DOCUMENT 009113 - ADDENDA

- A. Addendum No. Two.

- A. Project Name: Skatium Locker Room Renovation.
- B. Owner: Township of Haverford.
- C. Owner's Representative: C.B. Development Services, Inc.
- D. Architect: BKP Architects.
- E. Date of Addendum: October 4, 2024

Skatium Locker Room Renovation
Responses to Bidder Questions and Written Identification of Modifications to Project Documents

DRAWING NO:
A-601

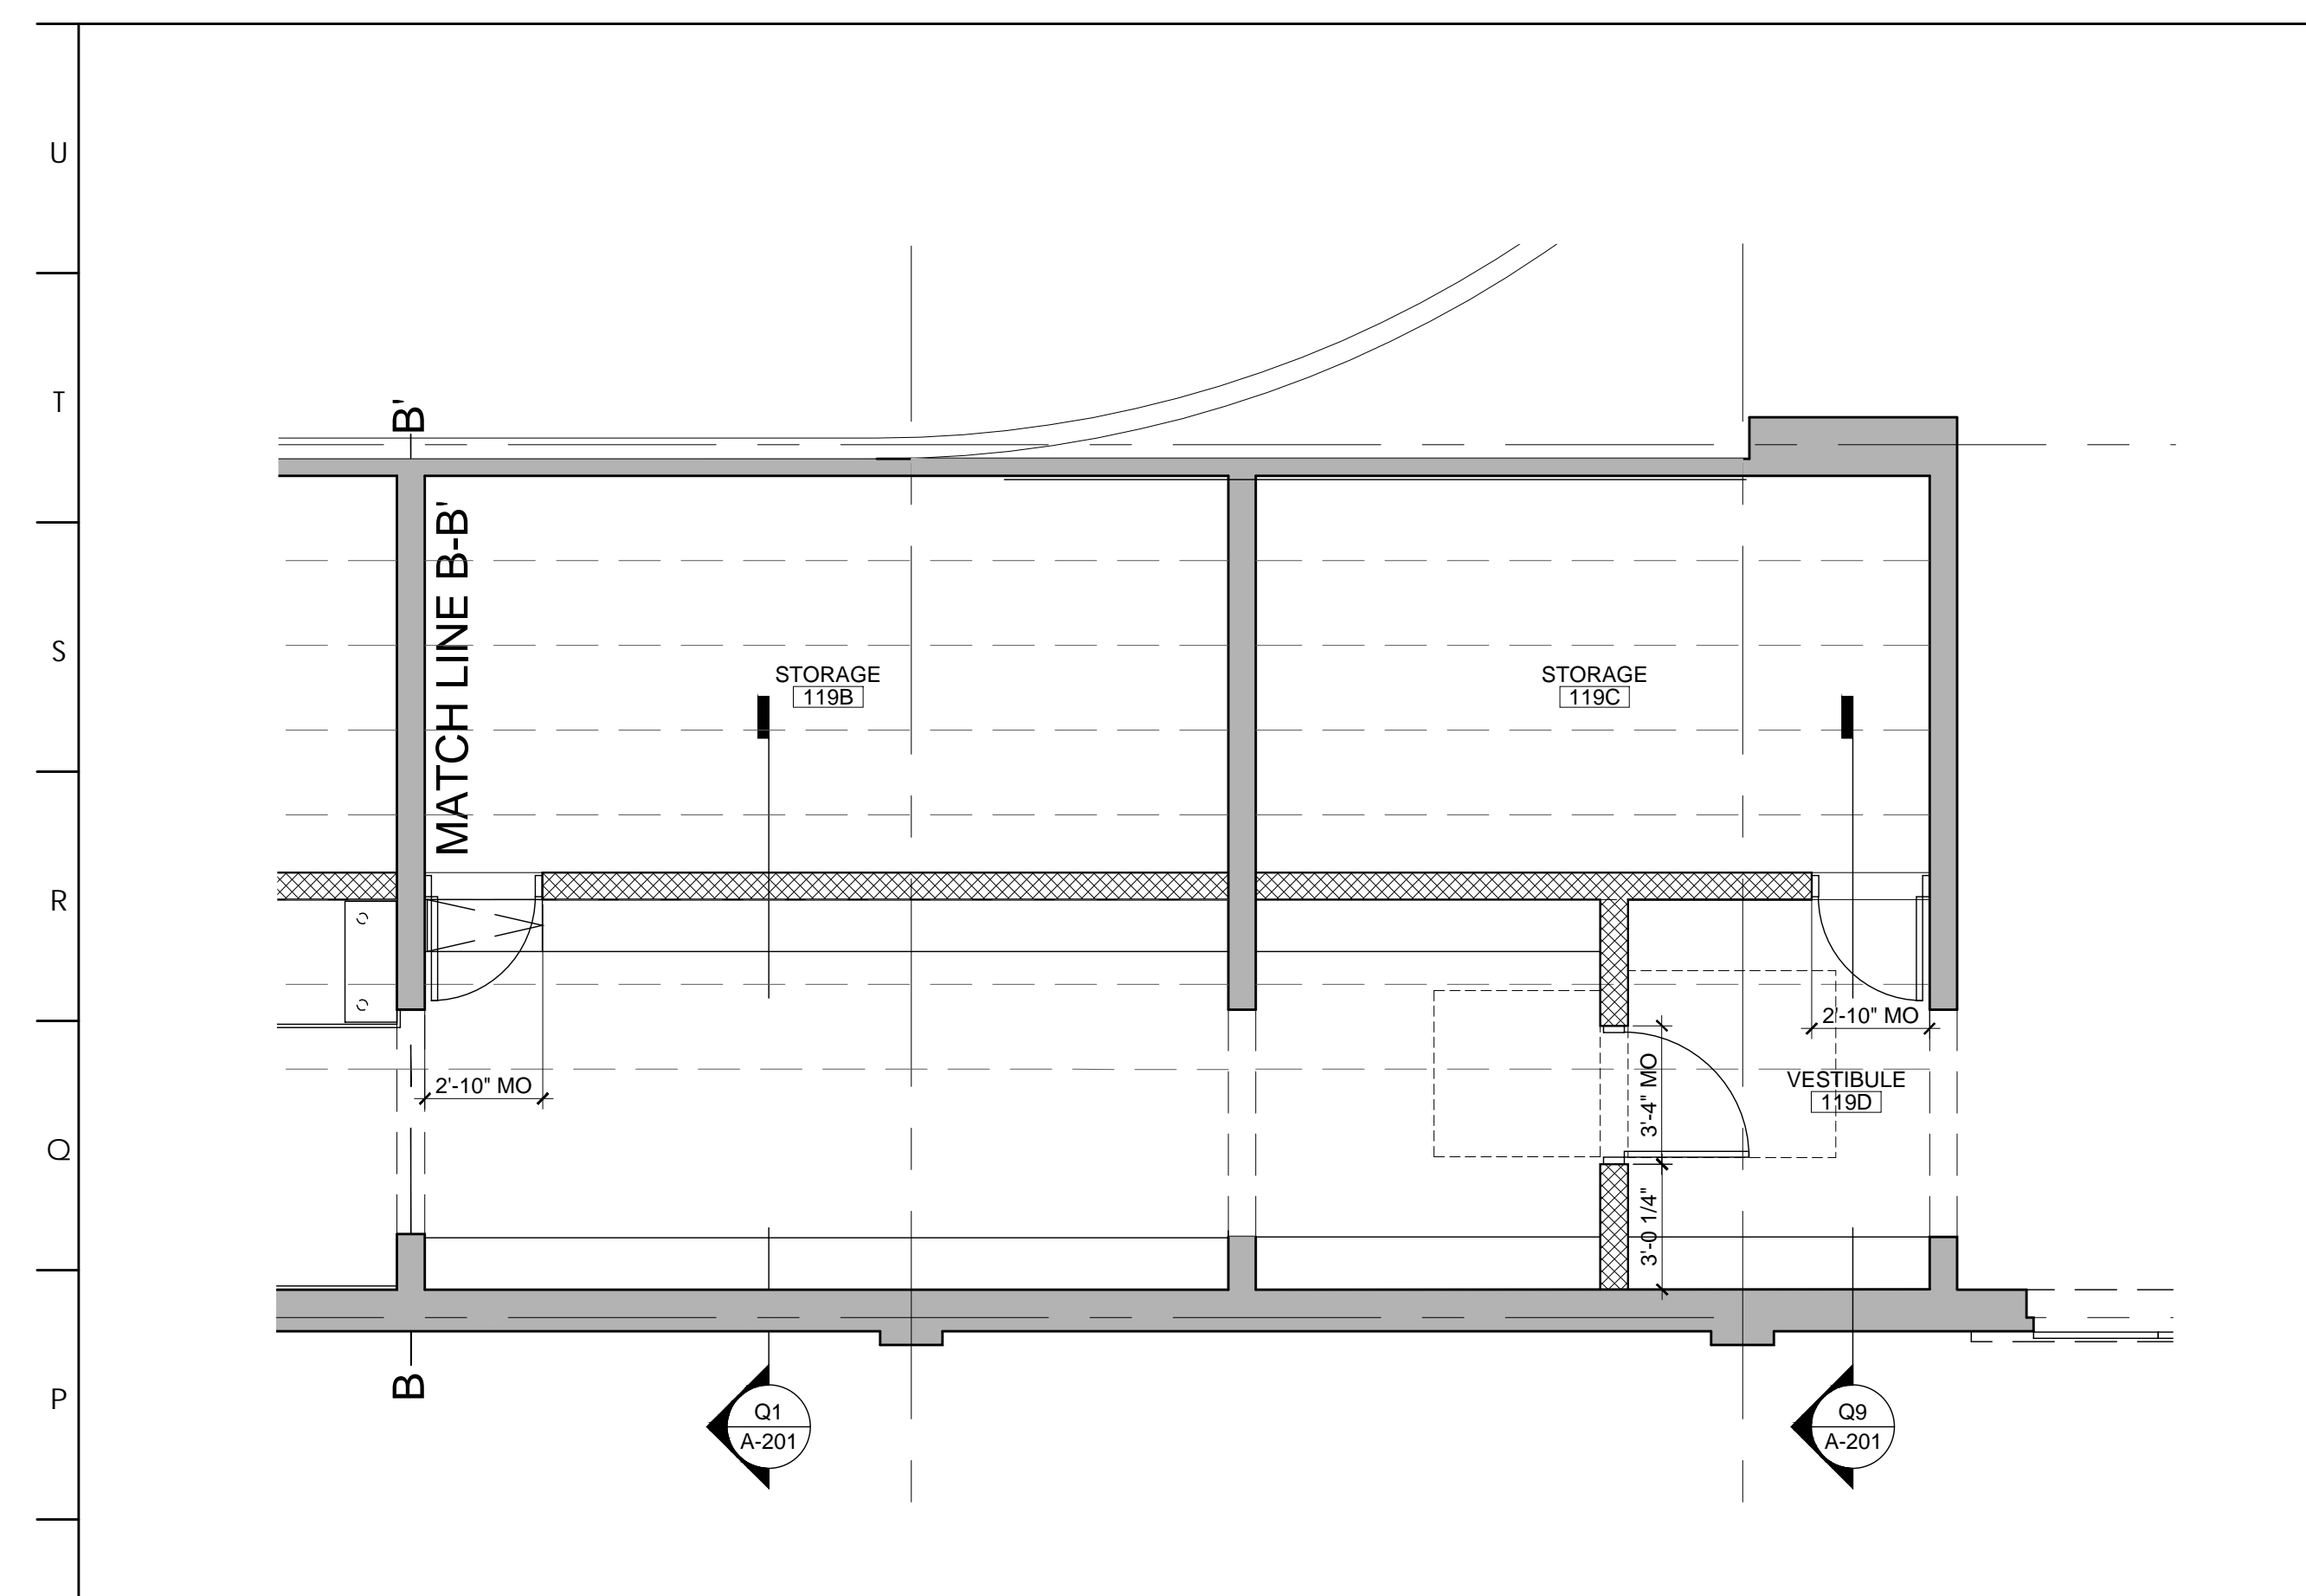
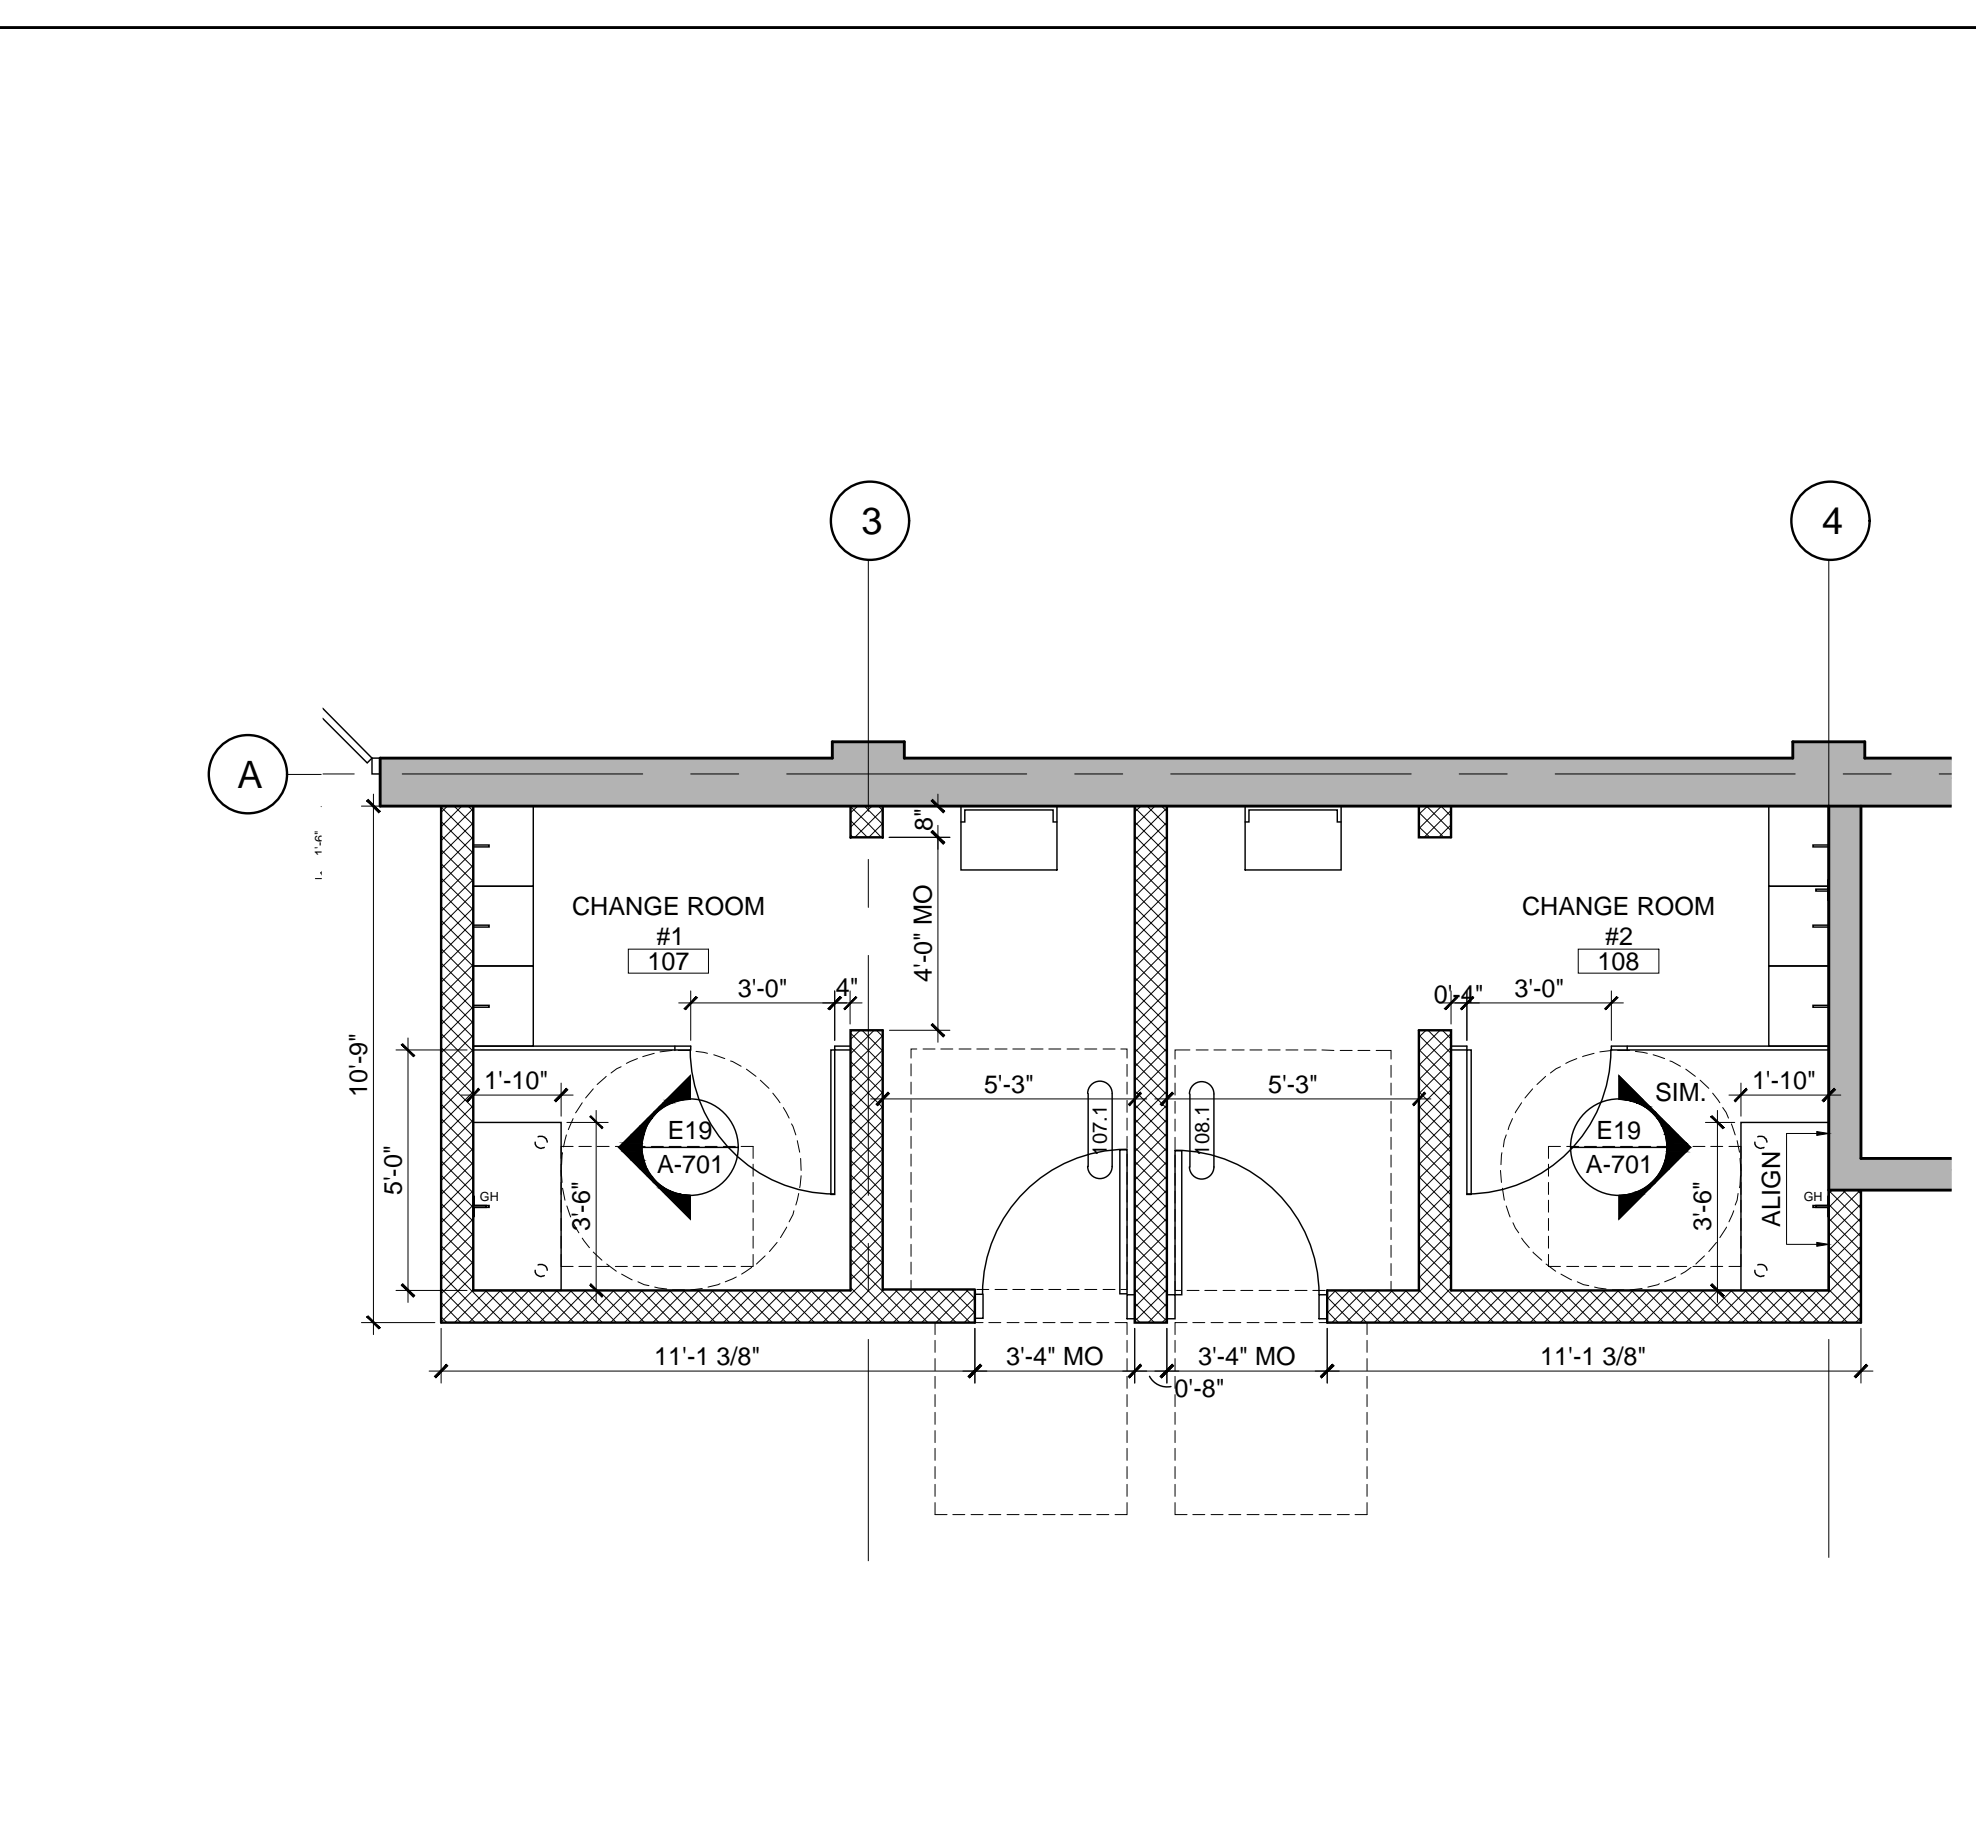
8. Several sheets reference Sheet A-100 which does not exist. Please advise.

- I. Drawing A-101 has been modified to include missing door hardware sets.
- J. Drawing A-601 has been modified, removing references to Sheet A-100, replaced with reference to Sheet A-701.

Reference to Sheet A-100 should have been A-701. Drawing sheets A-601 and A-602, which are affected by this change have been revised and issued with Addendum #2.
